# UNITED STATES PATENT AND TRADEMARK OFFICE

10/583,219

<b>Office Action Summary</b>	<b>Application No.</b> 10/583,219	<b>Applicant(s)</b> ARMIROLI ET AL.	
	<b>Examiner</b> MARINA TIETJEN	<b>Art Unit</b> 3753

## DETAILED ACTION

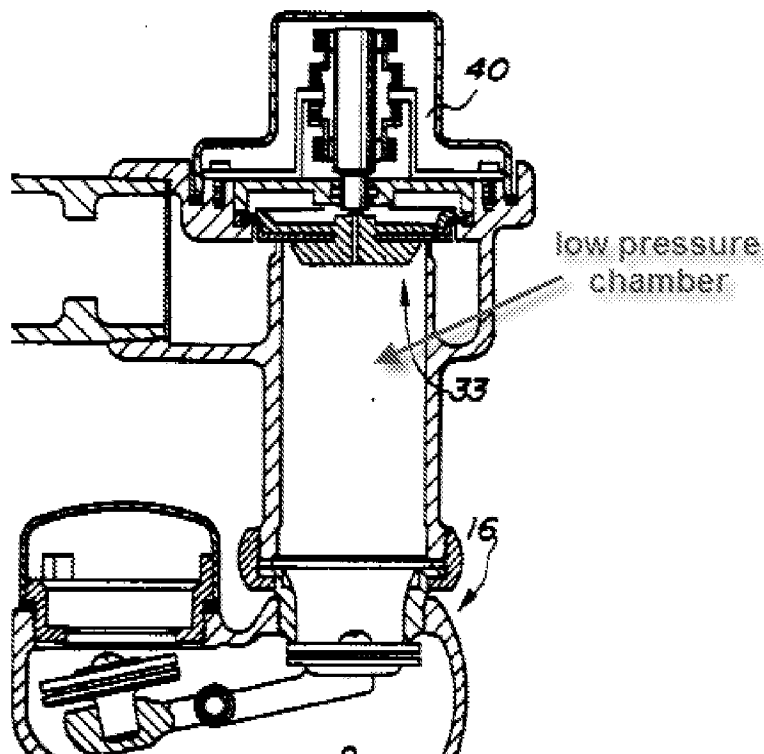
Tsutsui discloses a valve (fig. 5) comprising:

a valve body (42, 12) defining an inlet (area outside of seat 34), an outlet (inside of seat 34), and a seat (34),

a first valve member (33a) moveable between a first valve member closed position and a first valve member open position, wherein at least a portion of the first valve member (33a) is in contact with the seat (34) in the first valve member closed position, and the at least a portion of the first valve member (33a) is spaced a predetermined distance from the seat (34) when the first valve member (33a) is in the first valve member open position;

a piezoelectric portion (45a) for receiving a voltage, wherein at least a portion of the piezoelectric portion (45a) is moveable relative to the valve body;

wherein the valve body member (42, 12) defines a first valve member abutment (see labeled fig. 5 below), and wherein at least a portion of the first valve member (33a) contacts at least a portion of the first valve member abutment (labeled fig. 5) when the first valve member is in the first valve member open position;

wherein the first valve member (33a) is defined by an axial cavity (see labeled fig. 5 above) formed therein;

wherein the first valve member (33a) is further defined by a passageway (see labeled fig. 5 above) connecting the cavity (labeled fig. 5) in fluid communication with the inlet (see labeled fig. 5 above);

**FIG. 4**

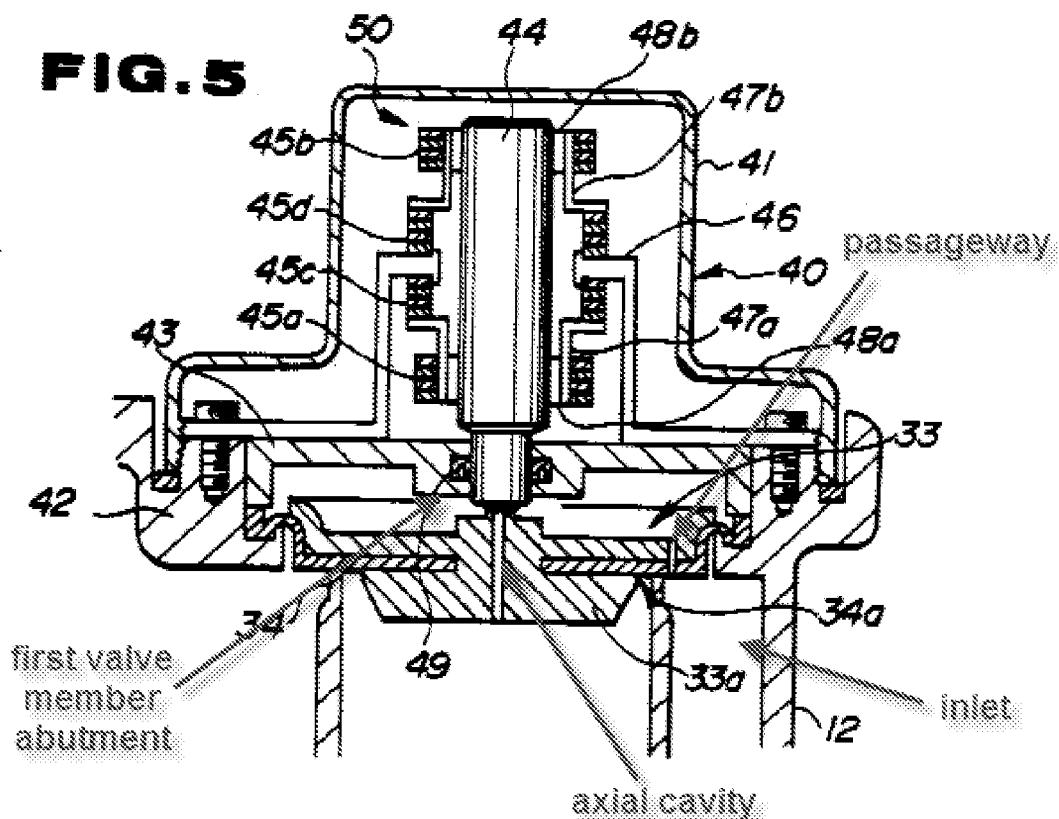
further comprising a first needle (44) coupled to the piezoelectric portion (45a), wherein the valve body (42, 12) is further defined by a first port (opening on top surface of valve member 33a which the first needle 44 sits on and blocks flow through), a low

pressure chamber (see labeled fig. 4 below), and a high pressure chamber (between the top surface of valve member 33a and member 43); the first needle portion (44) is moveable between a first needle open position and a first needle closed position; at least a portion of the first needle portion (44) is in contact with at least a portion of the first port (opening in top surface of valve member 33a) when the first needle (44) is in the first needle closed position, thereby defining a first boundary between the low pressure chamber and the high pressure chamber; and wherein the first valve member (33a), in the first valve member closed position, defines a second boundary between the low pressure chamber and the high pressure chamber;
